## ENGINEERING CHANGE NOTICE

1 ECN 657602

13a Description of Change		13b Design Baseline Document? <input type="checkbox"/> Yes <input checked="" type="checkbox"/> No  Complete revision update of PFP Emergency Lighting Study, HNF-3178 No physical modification done to the facility, so no USQ required per PFP FSP 5-8, section 2 23		
14a Justification (mark one) Criteria Change <input type="checkbox"/> Design Improvement <input type="checkbox"/> Environmental <input type="checkbox"/> Facility Deactivation <input type="checkbox"/> As Found <input checked="" type="checkbox"/> Facilitate Const <input type="checkbox"/> Const Error/Omission <input type="checkbox"/> Design Error/Omission <input type="checkbox"/>				
14b Justification Details Backup and emergency lights in buildings 236 Z, 270 Z 2701 ZD, and 2705-Z were upgraded by ECNs 649762 and 649761 This ECN documents those changes in this document				
15 Distribution (include name MSIN and no of copies)

# PFP EMERGENCY LIGHTING STUDY

GROUP N  
BUILDING 291-Z  
LOCATION General  
PRIORITY 10

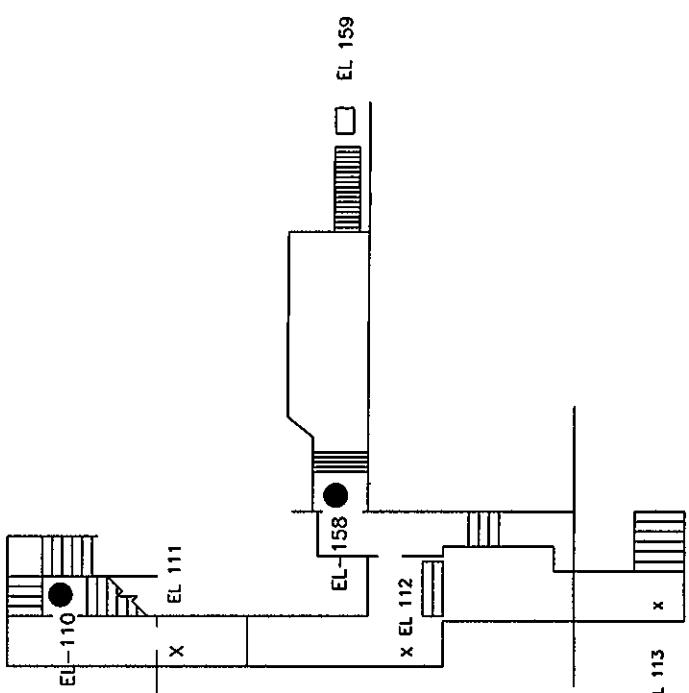
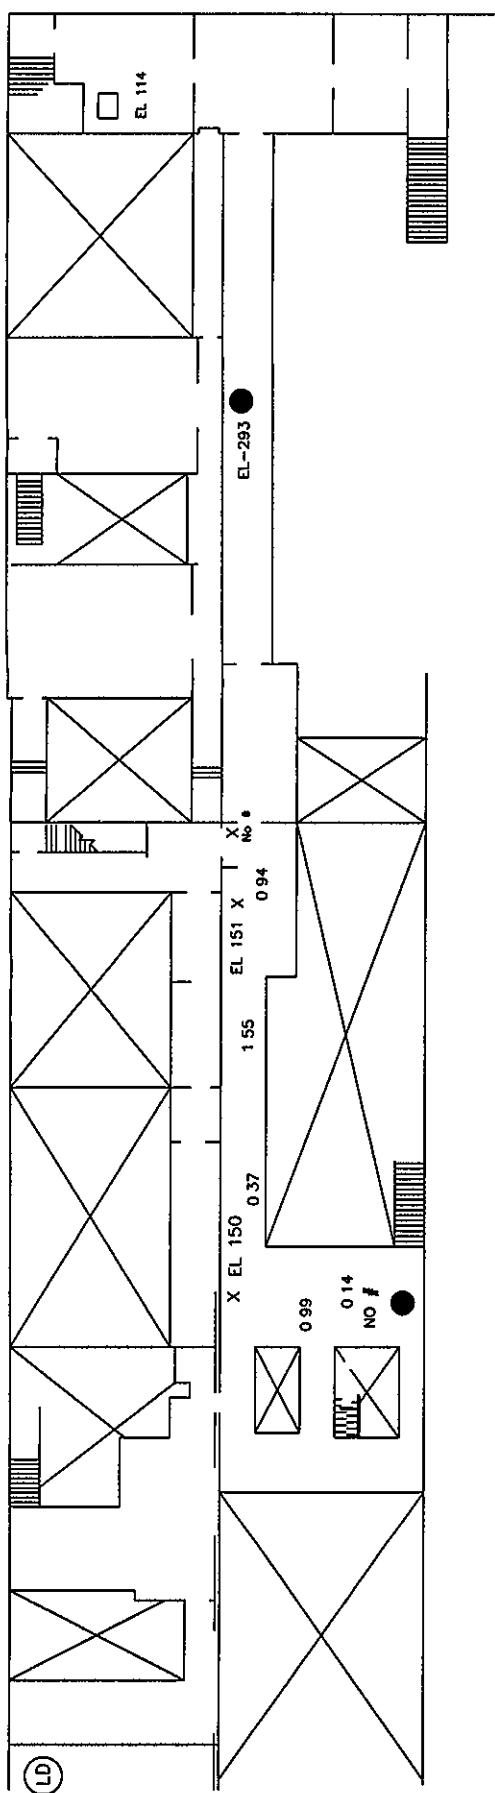
Due to the industrial nature of the building and lack of natural light, approximately 7 Backup Lights will be installed as shown in Appendix A. As Backup Lights, they are not required by NFPA, and will be placed on the quarterly maintenance cycle. This is the highest non-egress route priority.

④ Backup Lights to be added (7)

GROUP	M
BUILDING	243-Z, 2721-Z
LOCATION	All
PRIORITY	13

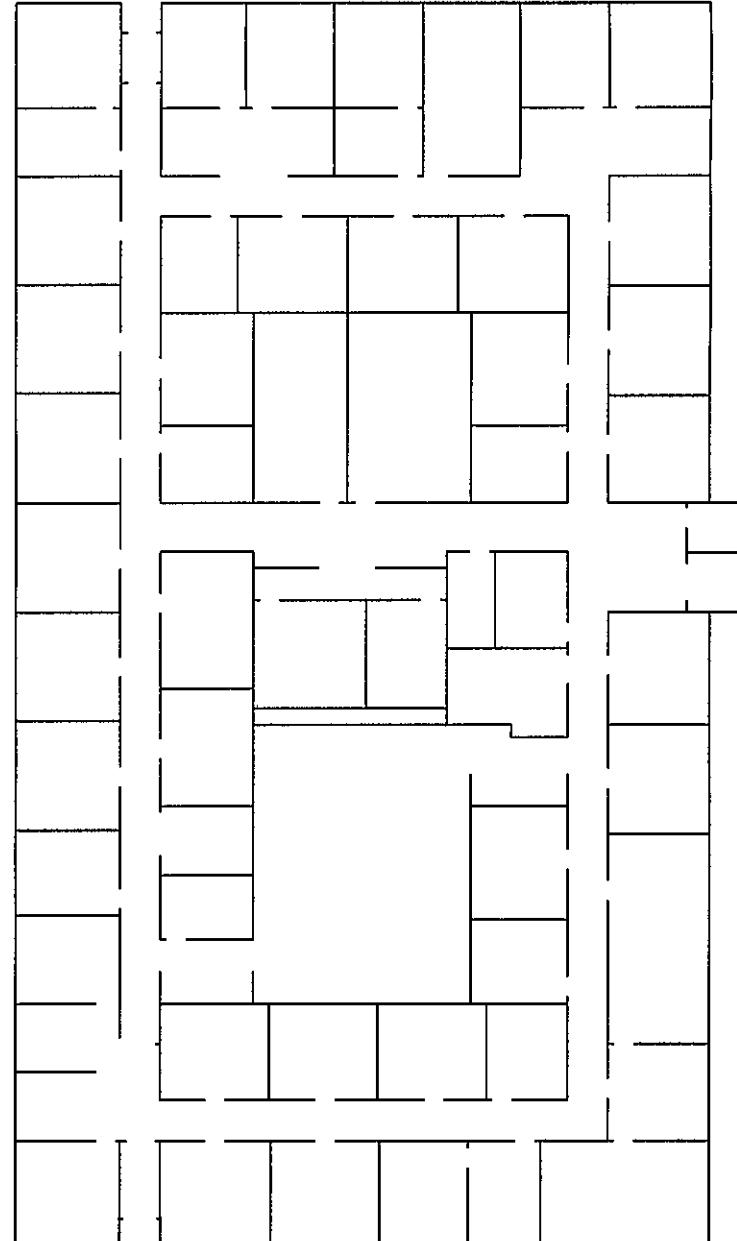
As a Special Purpose Industrial Occupancy, building 243-Z falls under Exception No 1 for non-routine habitation and does not require any emergency lighting. There are 6 lights

currently located in 243-Z. Two of these existing lights will be removed and the remainder classified as Backup Lights

- Existing lights which require no changes
- X Lights to be removed (2)
